Model: Kir-C ARDF (DF71)	Date: 25-May-01	No.: MB379001a

### **MB Correction**

## Modification Bulletin

### Page 3

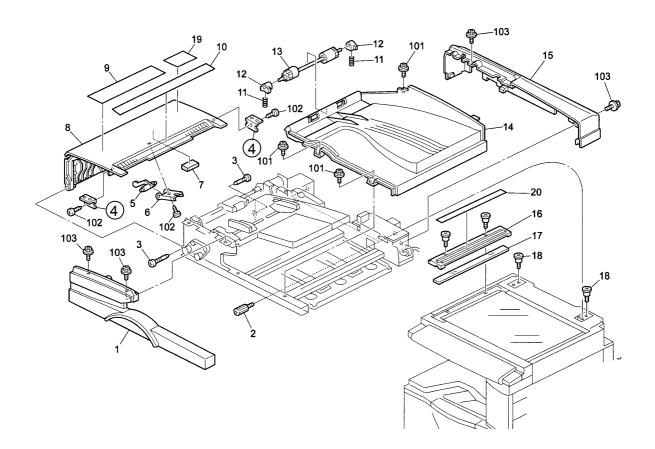
- Part Number Change -

Old part number	New part number	Description	Q'ty	Index	Note
A8594873	B3864873	Positioning Plate	2	4

Page 7
- Part Number Changes -

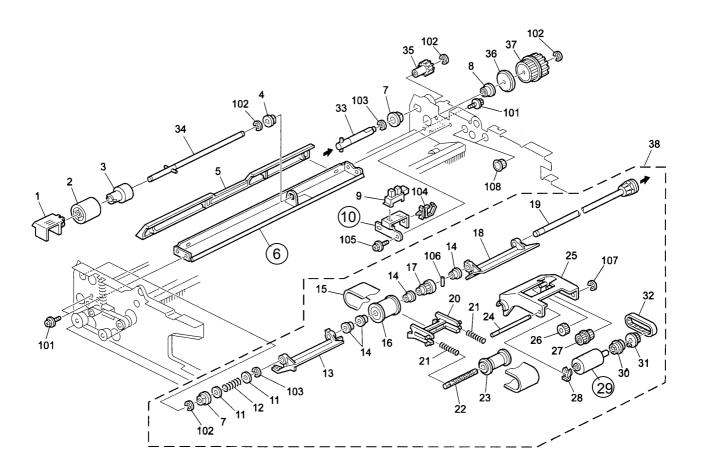
Old part	New part	Description	Q'ty	Index	Note
number	number				
A8591610	B3861610	Separation Stay	1	6	
A8591123	B3861123	Bracket – Sensor	1	10	
A8592161	B3862171	Pickup Roller	1	29

Page 9
- Part Number Changes -

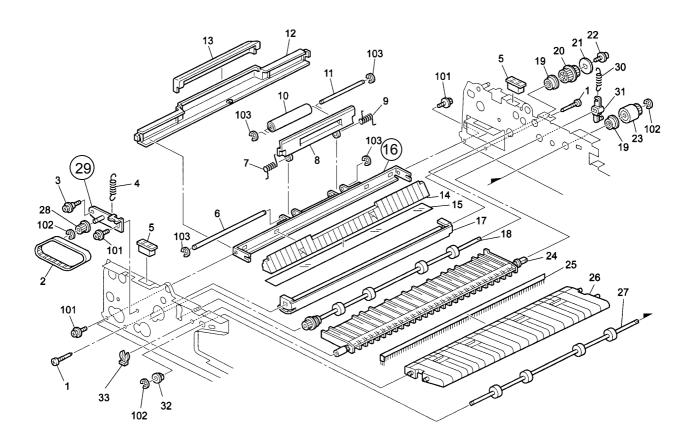
Old part	New part	Description	Q'ty	Index	Note
number	number				
A8591710	B3861710	Left Lower Stay	1	16	
A8594311	B3864311	Adjusting Pin – M6	1	29

Page 11
- Part Number Changes -

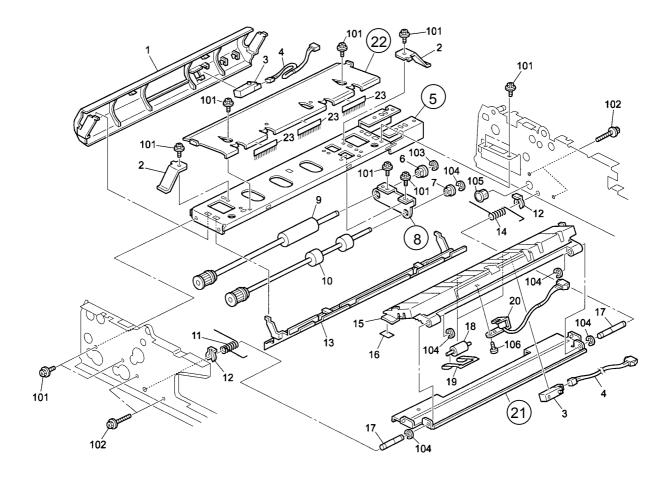
Old part	New part	Description	Q'ty	Index	Note
number	number				
A8591311	B3861311	Left Stay	1	5	
A8591320	B3861320	Bracket – Transport Roller	1	8	
A8593413	B3863413	Cover – Exit Guide Plate	1	21	
A8583231	B3863231	Guide Plate – Reverse	1	22

Page 13
- Part Number Changes -

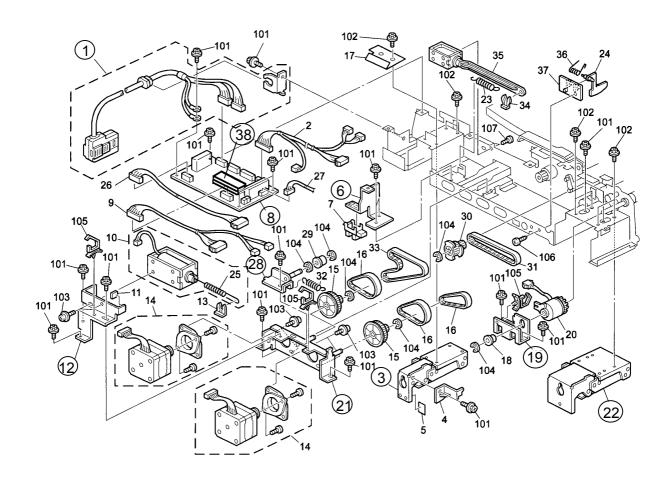
Old part	New part	Description	Q'ty	Index	Note
number	number				
A8595800	B3795800	Harness – Interface	1	1	
A8581831	B3861831	Right Hinge	1	3	
A8591122	B3861122	Right Sensor Bracket	1	6	
B3795500	B3795510	Main Control Board	1	8	
A8594411	B3864411	Bracket – Solenoid	1	12	
A8591315	B3861315	Bracket – Electromagnetic Clutch	1	19	
A8584111	B3794111	Bracket – Motor	1	21	
A8581811	B3861811	Left Hinge	1	22	
A8584131	B3794131	Adjusting Pin - Idler	1	28

- Addition -

Part number	Description	Q'ty	Index	Note
B3875660	ADF ROM	1	38

Page 15
- Part Number Changes -

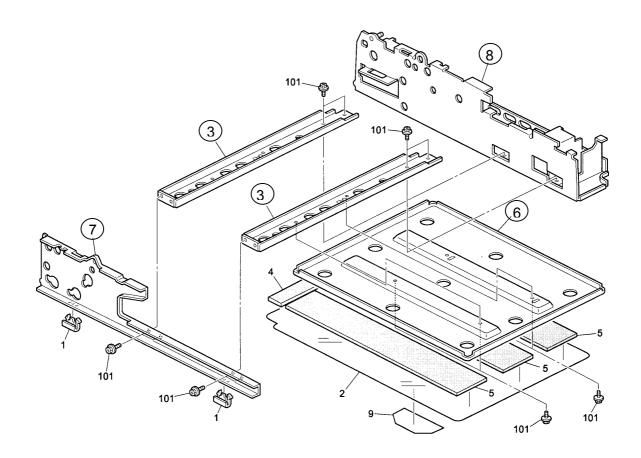
Old part	New part	Description	Q'ty	Index	Note
number	number				
A8591511	B3861511	Middle Stay	2	3	
A8593615	B3863615	Base - Platen Cover	1	6	
A8591211	B3861211	Front Side Plate	1	7	
A8591110	B3861110	Rear Side Plate	1	8

Page 9

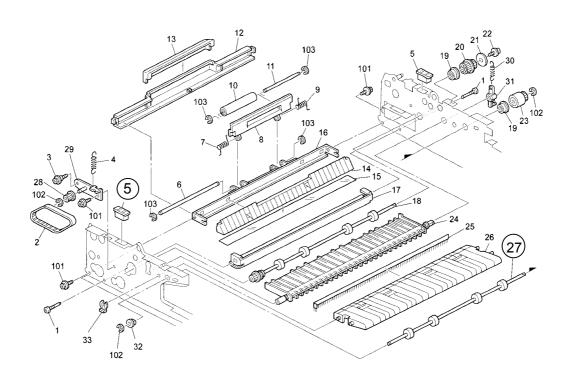
Old part   New part   Description		Q'ty	Index	Note	
number	number				
A8591181	B3514135	Magnet Catch - Original Table	1	5	
A8583140	B3863140	Reverse Roller – Drive	1	27

Page 13

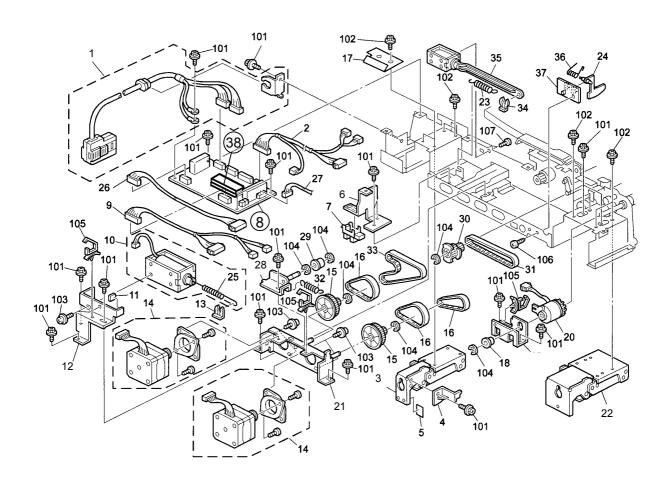
Old part	Old part   New part   Description   C		Q'ty	Index	Note
number	number				
B3795510	B3795520	Main Control Board	1	8	
B3875660	B3875680	ADF ROM	1	38

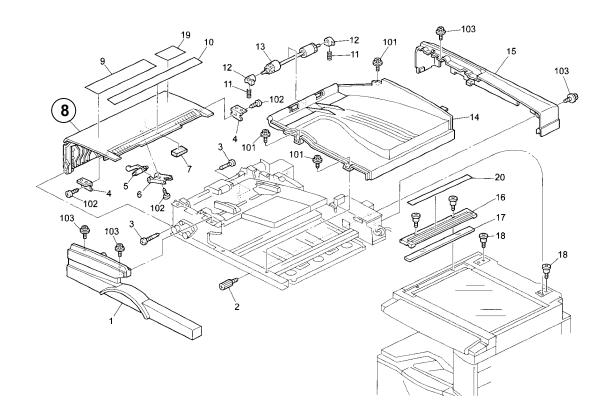
When the document approaches the Transport Rollers, it can sometimes contact the pullout lever due to warping in the Left Cover. The left cover has been changed to reduce the possibility of this happening.

Old part number	New part number	Description	Q'ty	Int	Page	Index	Note
B3864841	B3864842	Left Cover	1	X/O	3	8

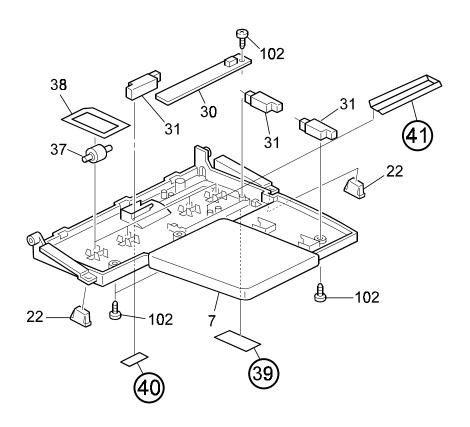
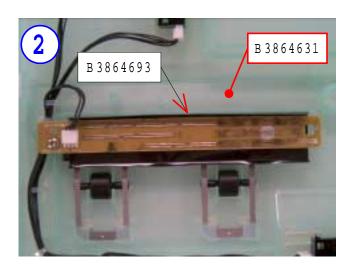
To cover the holes near the sensors and provide further shielding from static electricity, the following seals have been added.

New part	Description	Q'ty	Page	Index	Note
number					
B3864691	Mylar Seal - 28X107	1	5	39	
B3864692	Mylar Seal - 16X45	1	5	40	
B3864693	Mylar Seal	1	5	41

The Mylar Seal (B3864693) should be positioned below the Paper Size Sensor Board (B3865540) as shown:

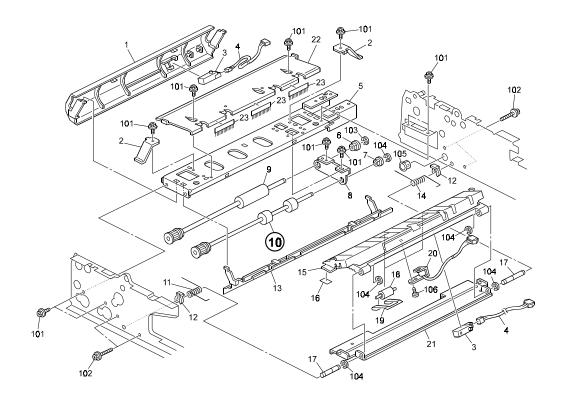
The following part has been changed due to a vendor change.

Old part	New part	Description	Q'ty	Int	Page	Index	Note
number	number						
A8593120	B3863121	Transport Roller - Middle	1	0/0	11	10

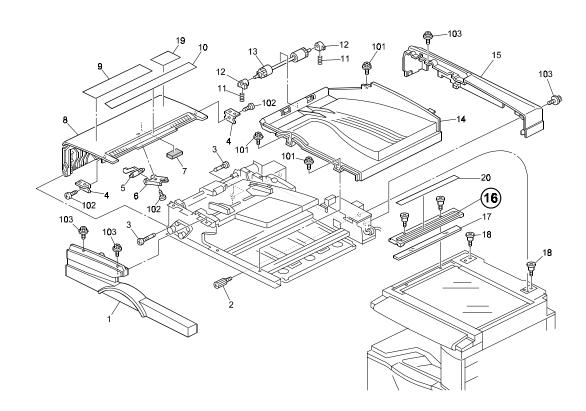
The shape of the Original Scale has been changed to ensure smoother feed of originals.

Old part	New part	Description	Q'ty	Int	Page	Index	Note
number	number						
B3867101	B3867102	Original Scale	1	0/0	3	16

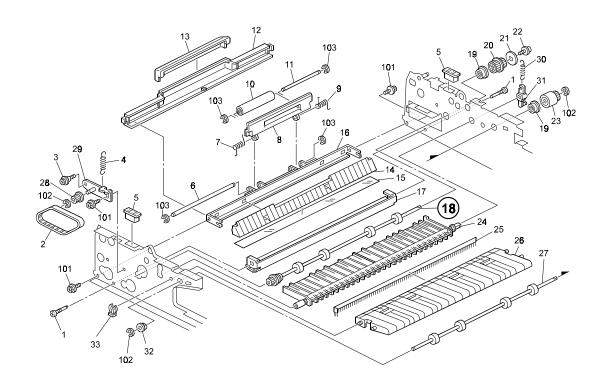
To minimize vibration of originals during paper feed, the following has been changed:

Old part	New part	Description	Q'ty	Int	Page	Index	Note
number	number						
A8593130	B3863130	Exit Roller - Drive	1	0/0	9	18

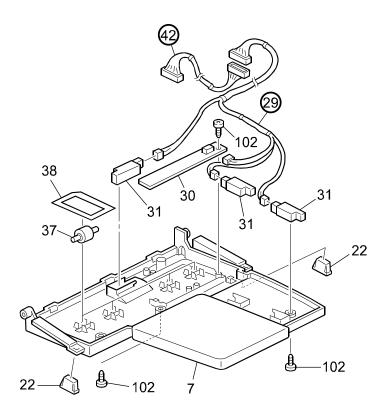
The following have been changed in accordance with parts used on the Model-UC for EMI Standards certification.

Old part	New part	Description	Q'ty	Int	Page	Index	Note
number	number						
A8595702	B4895715	Harness - Original Tray	1	X/X	5	29	
	B4895713	Relay harness	1	X/X	5	42

**Note:** When installing the new Original Tray Harness (B4895715), it is also necessary to install the Relay Harness (B4895713) at the same time. The interchangeability as a set for these parts is O/O.

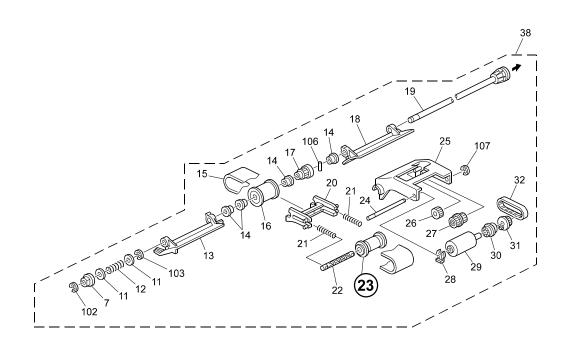
The following has been changed due to parts standardization with other models.

Old part	New part	Description	Q'ty	Int	Page	Index	Note
number	number						
A8592113—		Drive Roller - Paper Feed Belt	1		7	23	
	→ B3872113	Roller - Paper Feed Belt	1	0/0	7	23

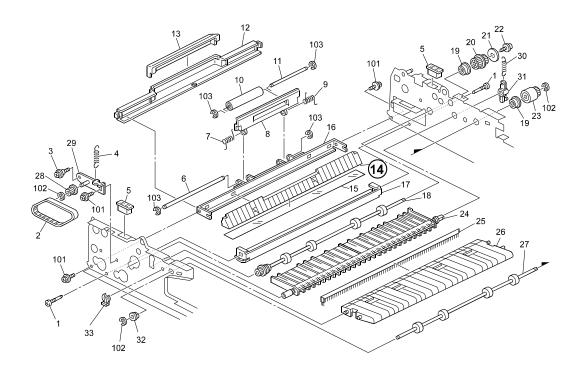
To ensure the junctions of the Lower Left Guide stay properly in position when the ADF is installed, the guide has been changed.

Old part number	New part number	Description	Q'ty	Int	Page	Index	Note
A8591721	A8591723	Left Lower Guide	1	X/O	9	14
